# UNITED STATES PATENT AND TRADEMARK OFFICE

<b>Interview Summary</b>	<b>Application No.</b>	<b>Applicant(s)</b>	
	10/613,605	DEROGATIS ET AL.	
	<b>Examiner</b>	<b>Art Unit</b>	
	Ernesto Garcia	3679

In re Application of:  
David DeRogatis *et al.*  
Serial No.: 10/613,605  
Filed: July 3, 2003  
For: **FASTENERS, RAILING  
SYSTEM AND METHOD OF  
ASSEMBLY**

**PROPOSED AMENDMENT – DO NOT ENTER**

FIG. 15

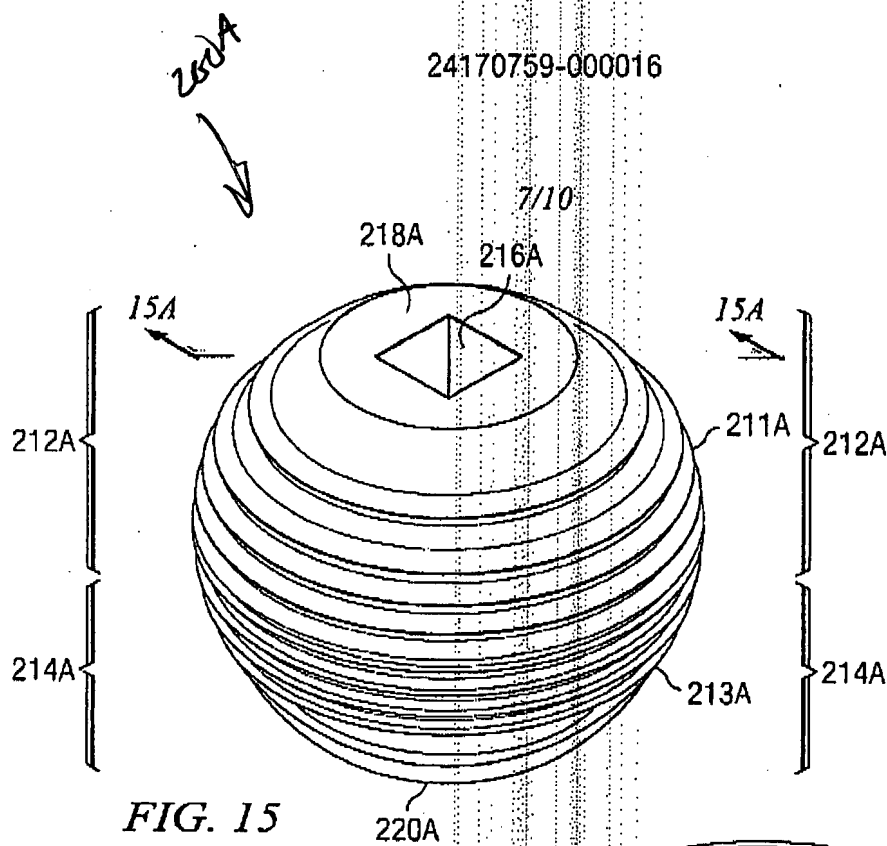
FIG. 15 – Aperture 216A is changed from a cylindrical opening to a rectangular opening;

The Examiner has objected to the drawings as failing to show the aperture 216A being rectangular. In response, the Applicants have amended Figures 15 and 15A to illustrate such an aperture. Accordingly, this objection has been overcome.

In addition, the Examiner has also objected to the specification as allegedly containing new matter, specifically with regard to the shape of the apertures illustrated in Figures 15, 15A and 15C. As noted above, however, FIG. 15, FIG. 15A and FIG. 15C have now been amended to illustrate the rectangular aperture discussed in the specification. Accordingly, it is believed the objection has also been overcome.

FIG. 15B

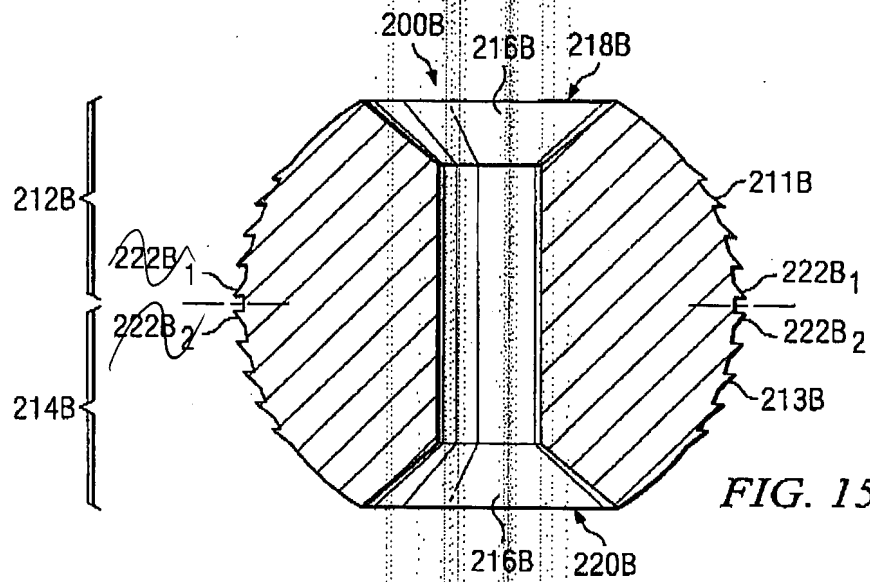
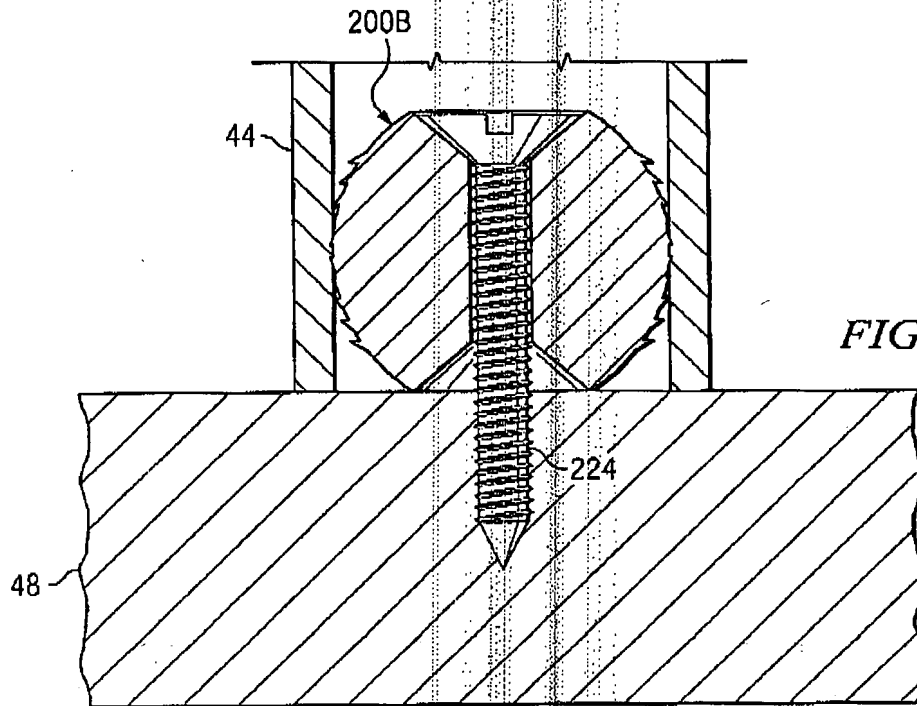
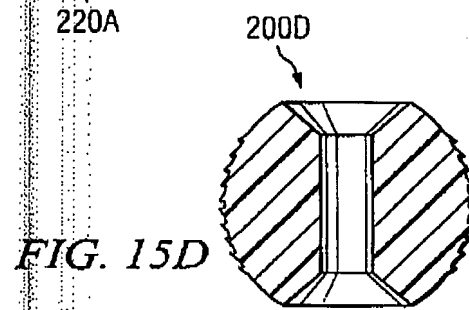
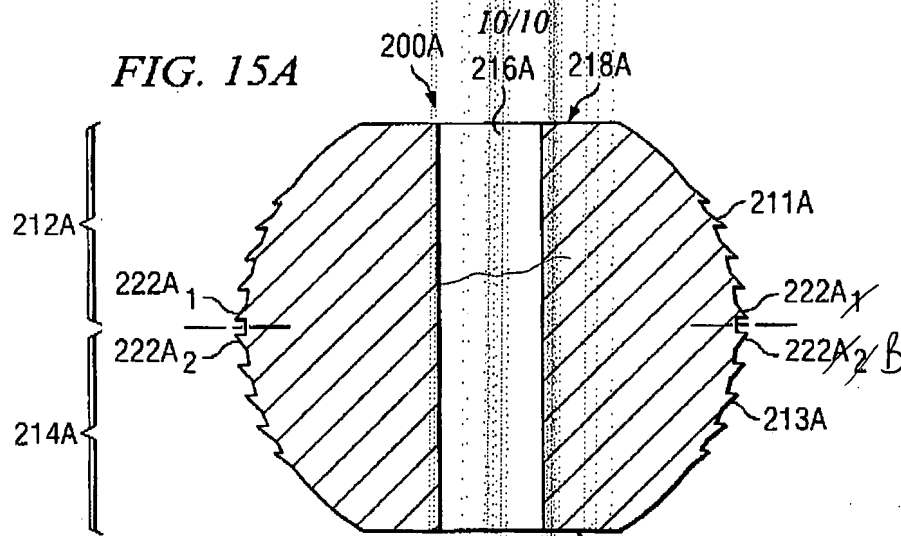
FIG. 15A – Aperture 216A is also changed from a cylindrical opening to a rectangular opening;

The Examiner has also objected to the drawings because the Examiner believes reference characters 211A (FIG. 15A) and 211B (FIG. 15B) have both been used to designate the same upper ridges. The Applicants respectfully disagree with the Examiner on this point. Specifically, the fastener in FIG. 15A is a different embodiment than the fastener in FIG. 15B. Similarly, designator "211A" is a different number than designator "211B." Accordingly, designator 211A is used to label the upper ridges of the fastener in FIG. 15A, while designator 211B is used to designate the upper ridges of the fastener in FIG. 15B. Thus, the Applicants respectfully assert that the upper ridges are properly labeled in the drawings.

The Examiner has also objected to the drawings because the Examiner believes reference characters 213A (FIG. 15A) and 213B (FIG. 15B) have both been used to designate the same lower ridges. The Applicants also respectfully disagree with the Examiner on this point. Specifically, the fastener in FIG. 15A is a different embodiment than the fastener in FIG. 15B. Similarly, designator "213A" is a different number than designator "213B." Accordingly, designator 213A is used to label the lower ridges of the fastener in FIG. 15A, while designator 213B is used to designate the lower ridges of the fastener in FIG. 15B. Thus, the Applicants respectfully assert that the lower ridges are properly labeled in the drawings.

The Examiner has also objected to the drawings because the Examiner believes reference characters 222A<sub>1</sub> (FIG. 15A) and 222B<sub>1</sub> (FIG. 15B) have both been used to designate the same

upper centered ridges. The Applicants respectfully disagree with the Examiner on these points. Specifically, the fastener in FIG. 15A is a different embodiment than the fastener in FIG. 15B. Similarly, designator "222A<sub>1</sub>" is a different number than designator "222B<sub>1</sub>." Accordingly, designator 222A<sub>1</sub> is used to label the upper centered ridge of the fastener in FIG. 15A, while designator 222B<sub>1</sub> is used to designate the upper centered ridge of the fastener in FIG. 15B. Thus, the Applicants respectfully assert that the upper centered ridges are properly labeled in the drawings.

The Examiner has also objected to the drawings because the Examiner believes reference characters 222A<sub>2</sub> (FIG. 15A) and 222B<sub>2</sub> (FIG. 15B) have both been used to designate the same lower centered ridges. The Applicants respectfully disagree with the Examiner on these points. Specifically, the fastener in FIG. 15A is a different embodiment than the fastener in FIG. 15B. Similarly, designator "222A<sub>2</sub>" is a different number than designator "222B<sub>2</sub>." Accordingly, designator 222A<sub>2</sub> is used to label the lower centered ridge of the fastener in FIG. 15A, while designator 222B<sub>2</sub> is used to designate the lower centered ridge of the fastener in FIG. 15B. Thus, the Applicants respectfully assert that the lower centered ridges are properly labeled in the drawings.
